# Commission of Architectural Review SUBMISSION APPLICATION

LOCATION OF WORK: 22 SOUTH BOULEVARD DATE: 4/23/14  
RICHMOND VA 23220

RE: Application No. 08-069  
22 South Boulevard

**Application No. 08-069** (Campus Apartments)  
22 South Boulevard

## Problem Identification

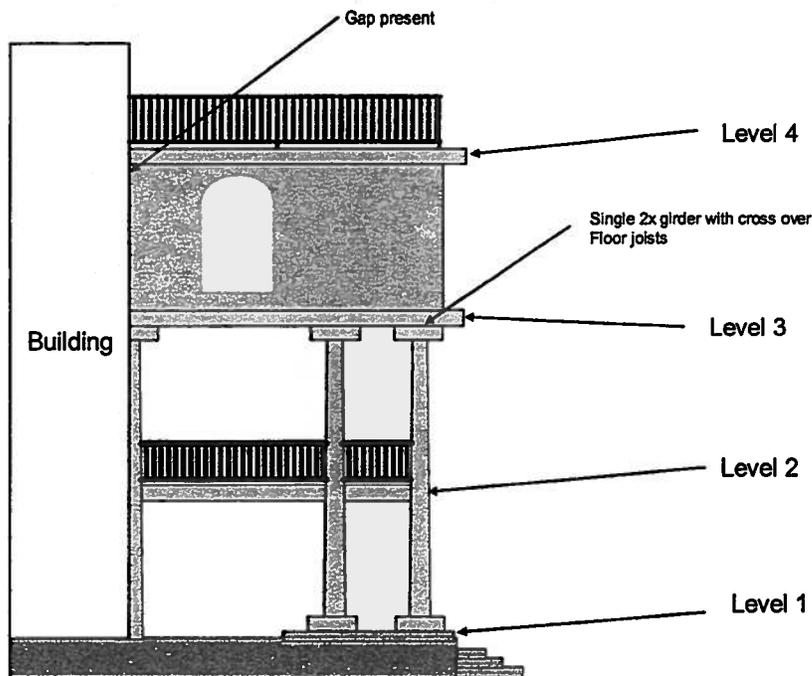
Level four at the building intersection has pulled away from the building structure. New wood scabbed to lengthen joists as well as installation of a new band was previously completed in an attempt to remedy the problem. New deck wood was apparently installed as an attempt to bridge the gap caused by the settling on the outside or street side of the balcony.

Level three has a number of problems that led to the movement of level four, as detailed below:

- Outer girder carrying the floor joist load from column to column is only a single 2-inch member with significant sag between support posts
- Compression of cross-sectional area of each floor joist is present at intersection with single 2-inch girder
- Load bearing center line is located on the outer 1/3 of the columns, not in the center
- Loose water damaged joists were noted
- Outer portion and side of deck above allows water to infiltrate to structure

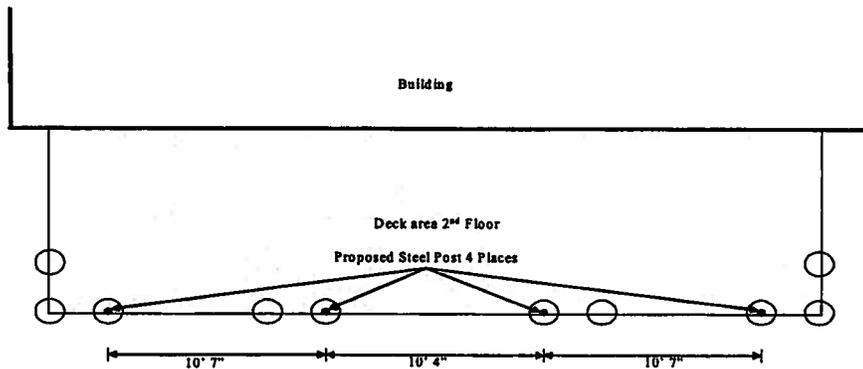
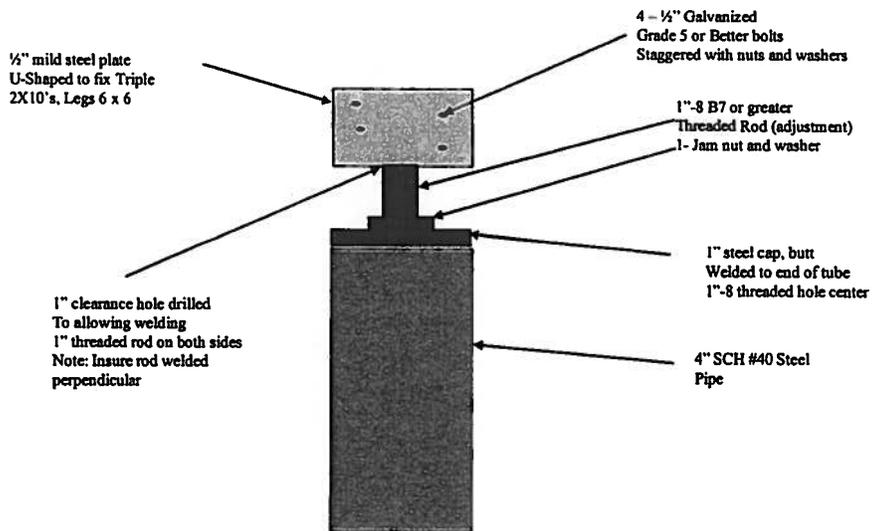
Company carpenter removed ceiling material on the bottom side of levels three and four which allowed for further detailed inspection.

Both level three and four include floor joists that extend from building structure to street side of balcony. Wood appears to be structurally sound and only minor water damage noted.

- Note:
1. Steel Post 3" Sch #40 x ~17.5'
  2. Post Centered in Pillar
  3. Post to bear on 1/2" 12" x 12" plates at bottom of Pillar
  4. Plate to pipe mount can be field fabricated (I.e. Short coupling) to aid installation

2. Once support posts are in place, install triple 2 x 10 field constructed girder across all four support posts, cantilevering them past post 2 and 7, to support outside load.
